# Groundwater Application Review Summary Form

Application # G- 18342

GW Reviewer Joe Kemper Date Review Completed: 9/18/2023

TO: Water Rights Section Date 9/18/2023  
 FROM: Groundwater Section Joe Kemper Reviewer's Name  
 SUBJECT: Application G- 18342 Supersedes review of 9/7/2016 Date of Review(s)

Water-Level Trends in Nearby Wells

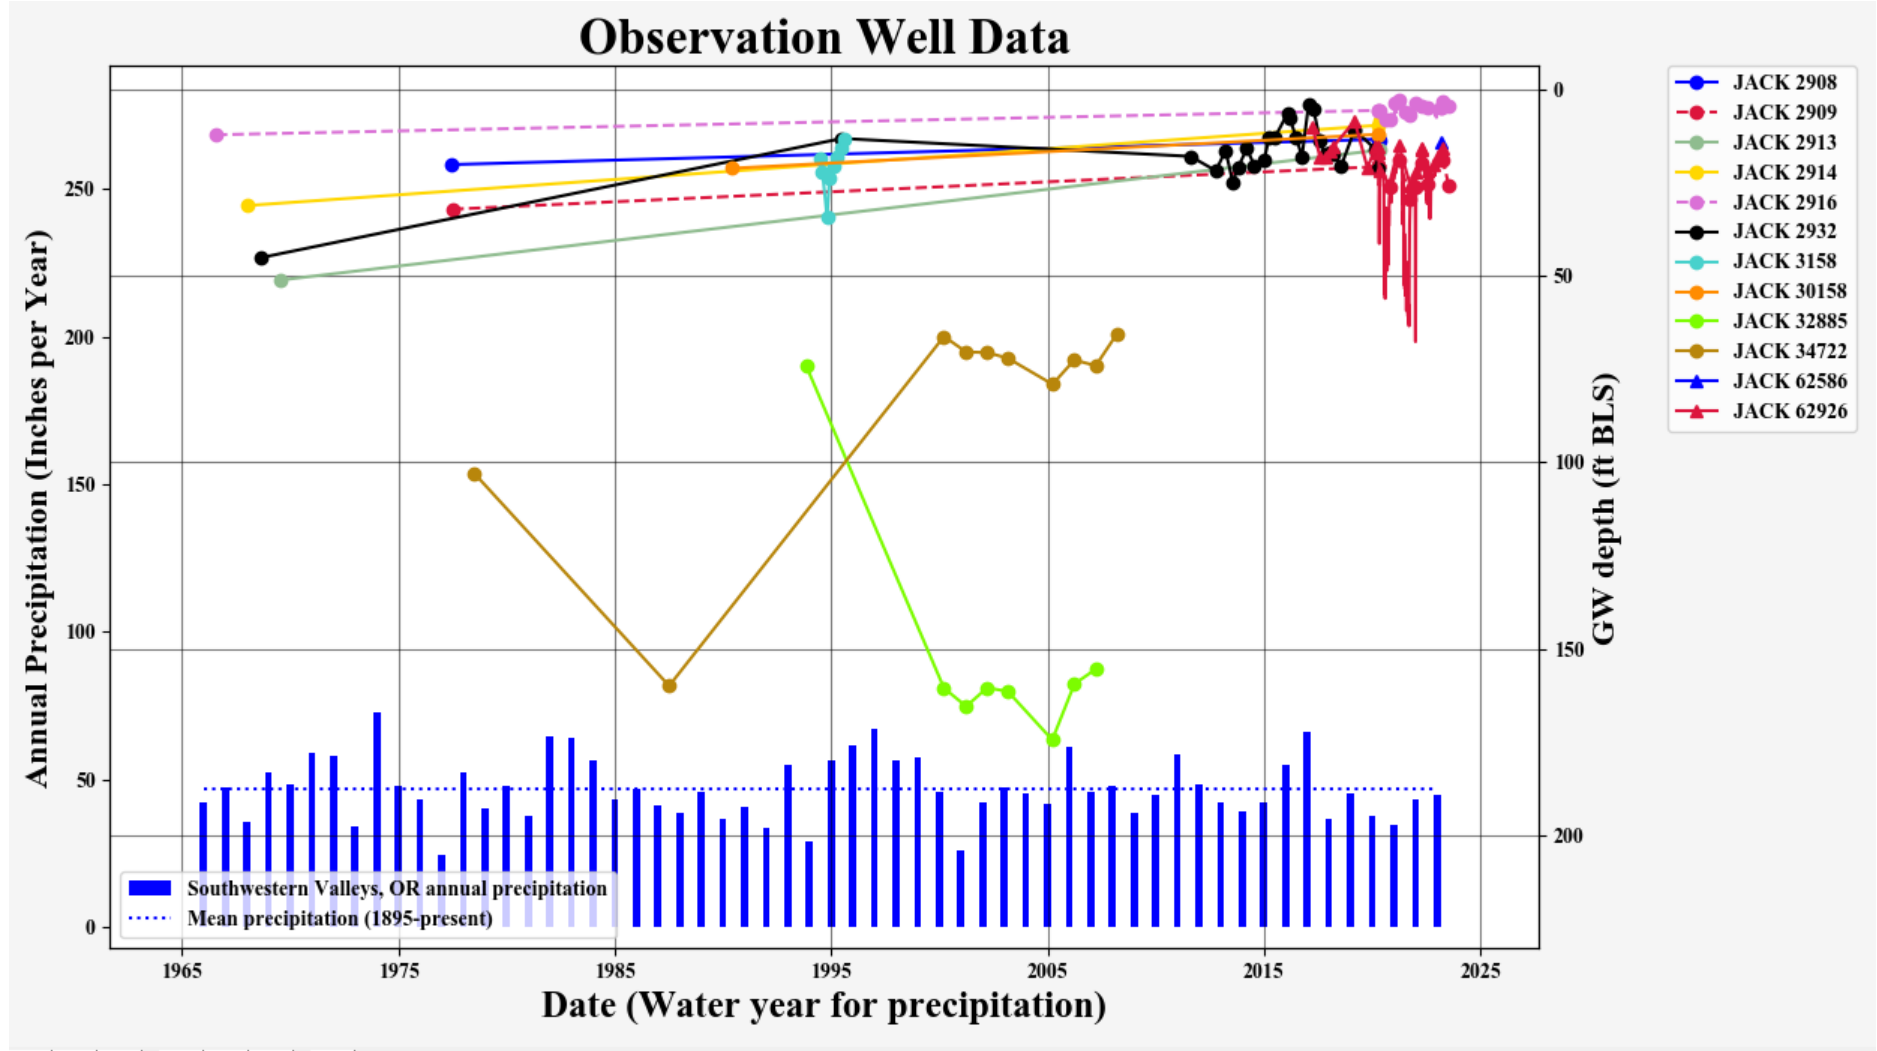
B3. **Groundwater availability remarks:** The applicant requests the use of 0.167 cfs (75 gpm) from a single proposed well for 30 acres of nursery use. The applicant's well would access an aquifer hosted in the secondary porosity (fractures and joints) within early Western Cascades volcanics (Wiley and Smith, 1993) (Hladky, 1992). Water levels in adjacent observation wells indicate moderate seasonal fluctuations (10-15 feet) with larger drawdown (>50 feet) resulting from well-to-well interference. Water level records do not indicate any year-on-year declines at this time so the resource does not appear to be over-appropriated as per current understanding of pertinent rule and statute. However, the target aquifer has relatively low storage and is constrained by the extent and interconnection of water bearing fractures, making the target aquifer prone to persistent seasonal declines and well-to-well interference.

OFR 2021-05 (Kemper, 2021, available at [https://www.oregon.gov/owrd/wrdreports/OFR\\_2021\\_05\\_report.pdf](https://www.oregon.gov/owrd/wrdreports/OFR_2021_05_report.pdf)) documents the results of a pumping test conducted by OWRD staff in April 2020, in which well XP-7 (JACK 30158) was pumped for 8 hours at 142 GPM causing 14.6 feet of drawdown at XP-5 (JACK 2909) and 7.6 feet of drawdown at Harrington-2 (JACK 62926 under permit G-16926). This report shows that the target aquifer consists of a heterogenous fracture network that functions as a single aquifer but has interconnected fractures that propagate pressure quickly between wells that share that fracture system. To assess injury from this application, Theis distance drawdown modeling with aquifer parameters from OFR 2021-05 estimates that pumping from the proposed well location at the requested rate (0.1671 cfs) would cause 25-85 feet of drawdown at JACK 62926 within 1-5 days. This would trigger decline conditions for JACK 62926 and for this application and require regulation of the proposed well. In addition, groundwater in the target aquifer flows primarily through fractures, so full penetration of senior groundwater users is not necessarily required for a finding of injury (OAR 690-008-0001(8). **Considering the hydrogeologic context and high magnitude of interference, the requested use is determined to injure JACK 62926 and is not within the capacity of the resource.**
